**Si3402-A-GM to Si3402-B-GM EVB Modifications
Version 0.4**

The Si3402-B-GM device requires component value changes from those used with the Si3402-A-GM evaluation board (EVB) reference design. Table 1 below is a summary of the required modifications.

Si3402ISO (Flyback, Isolated) EVB Reference Design – 5V

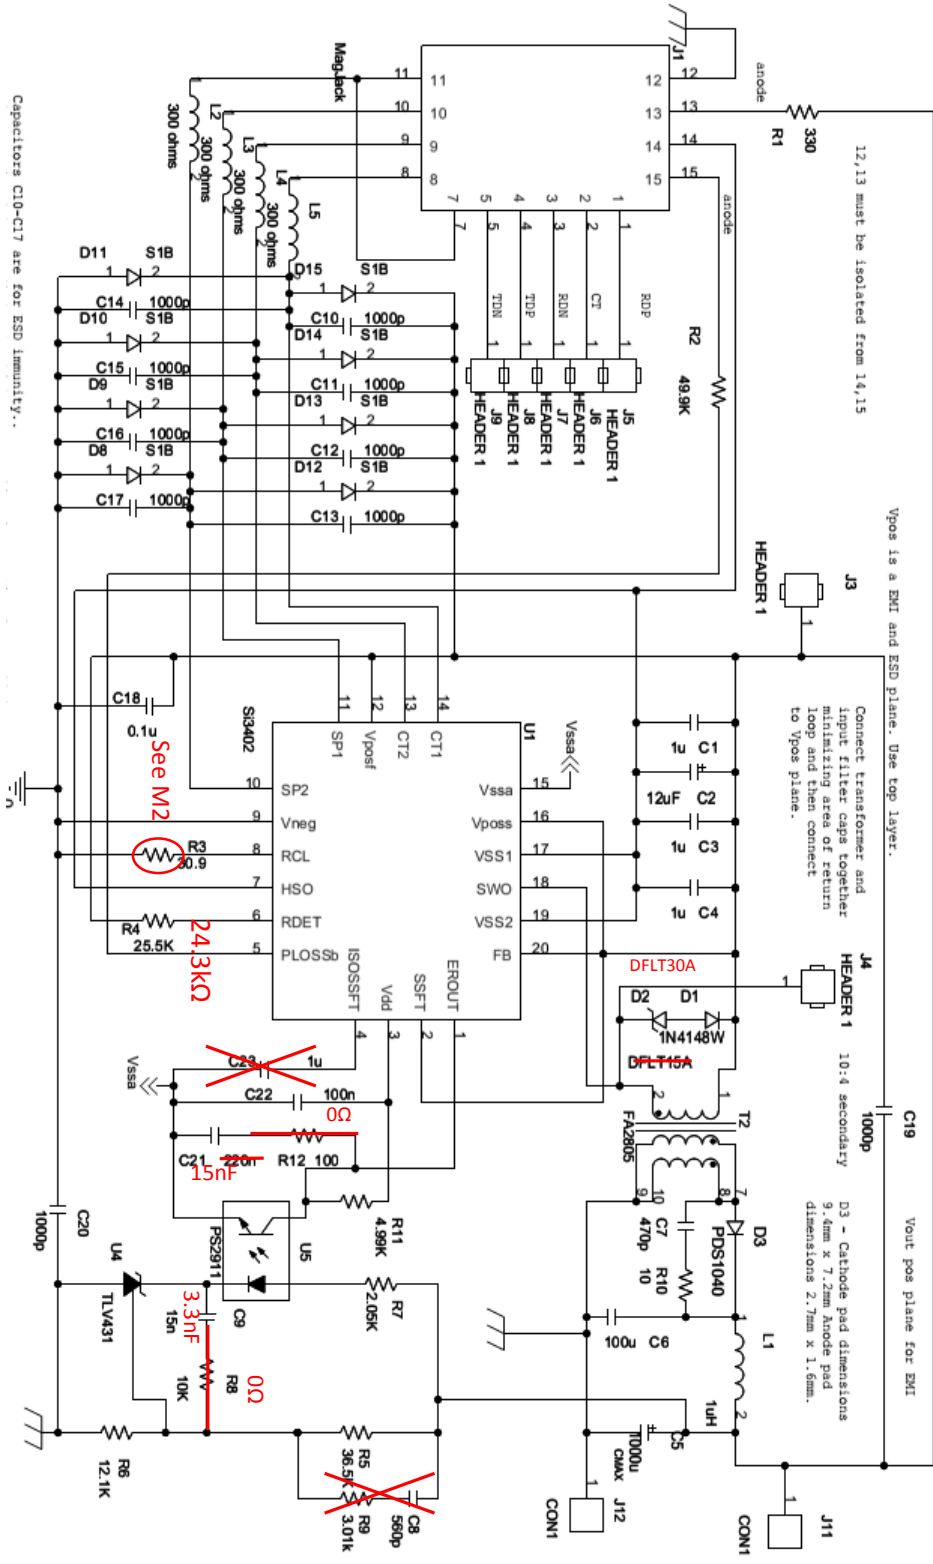
Item	Modification description	Application design effect
M1	Detect resistor value change	The former 25.5kΩ detect resistor must be replaced by 24.3kΩ 1%
M2	Classification resistor value change	The following 1% resistors must be used: Class0: 681.00 or higher (It is optional to place this resistor) Class1: 140.0 Class2: 75.0 Class3: 48.7 Class4: 33.2
M3*	ISO EVB DCDC 3.3V changes Flyback	C8, R9 & C23 are not need—Do not populate them. C9=10nF, C21=33nF, R12=475 Ω & R8=1.1k Ω Replace D2 (DFLT15A) with DFLT30A * See Revision Notes
M4	ISO EVB DCDC 5V changes Flyback	C8, R9 & C23 are not need—Do not populate them. C9=3.3nF, C21=15nF, R12=0 & R8=0 (place zero Ω resistors) Replace D2 (DFLT15A) with DFLT30A
M5	ISO EVB DCDC 12V changes Flyback	C8, R9 & C23 are not need—Do not populate them. C9=10nF, C21=15nF, R12=0, R8=0 (place zero Ω resistor) R7=3k Replace D2 (DFLT15A) with DFLT30A
M6	DCDC reference voltage change (Buck case only)	Now 1.35V instead of previous 1.23V. Thus, R5 changes from 2.87kΩ 1% to 3.24kΩ 1%. R6 (1%) is modified according to this table:

- Updated M3, the 3.3V Isolated Flyback case.
 - Explanation: 3.3V Flyback compensation was updated to address a small overshoot condition under no-load conditions (3.66V is allowed, the overshoot was 3.73V). The problem is fixed with revised compensation with a resulting overshoot of about 3.5V.
 - If a no-load condition is unlikely, the customer may keep the original M3 change recommendation:
 - C8, R9 & C23 are not need—Do not populate them
 - C9=3.3nF, C21=15nF, R12=0 & R8=0 (place zero Ω resistors)
 - Replace D2 (DFLT15A) with DFLT30A

Si3402 (Buck, Non-Isolated) EVB Reference Design - 5V

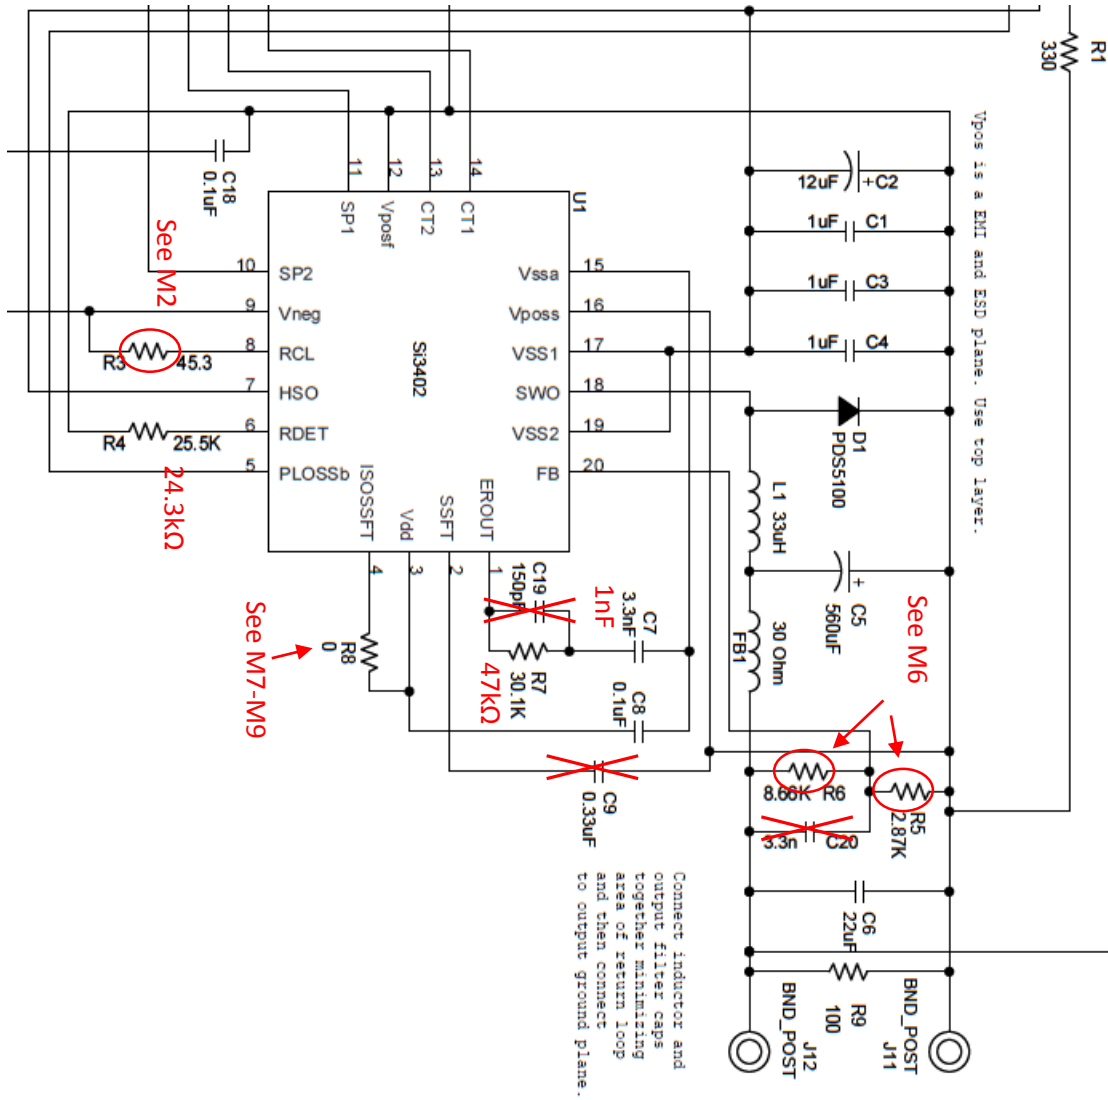
Vout Target	R5 kΩ	R6 kΩ	Vref	Vout Measured
		3.3	3.24	4.64	1.35	3.37
		5	3.24	8.66	1.35	4.96
		9	3.24	18.2	1.35	8.93
		12	3.24	25.5	1.35	11.98
M7	BUCK EVB DCDC 3.3V compensation network changes	C19, C20 & C9 are not need—Do not populate them. R8 can be populated with a 0Ω resistor (creating a short between pins 3 and 4) or left unpopulated, since the ISOSSFT function is now internal (see datasheet). C7=1nF, R7=47kΩ ±20%.				
M8	BUCK EVB DCDC 5V compensation network changes	C19, C20, R8 & C9 are not need—Do not populate them. R8 can be populated with a 0Ω resistor (creating a short between pins 3 and 4) or left unpopulated, since the ISOSSFT function is now internal (see datasheet). C7=1nF, R7=47kΩ ±20%.				
M9	BUCK EVB DCDC 12V compensation network changes	C19, C20, R8 & C9 are not need—Do not populate them. R8 can be populated with a 0Ω resistor (creating a short between pins 3 and 4) or left unpopulated, since the ISOSSFT function is now internal (see datasheet). C7=1nF, R7=47kΩ ±20%.
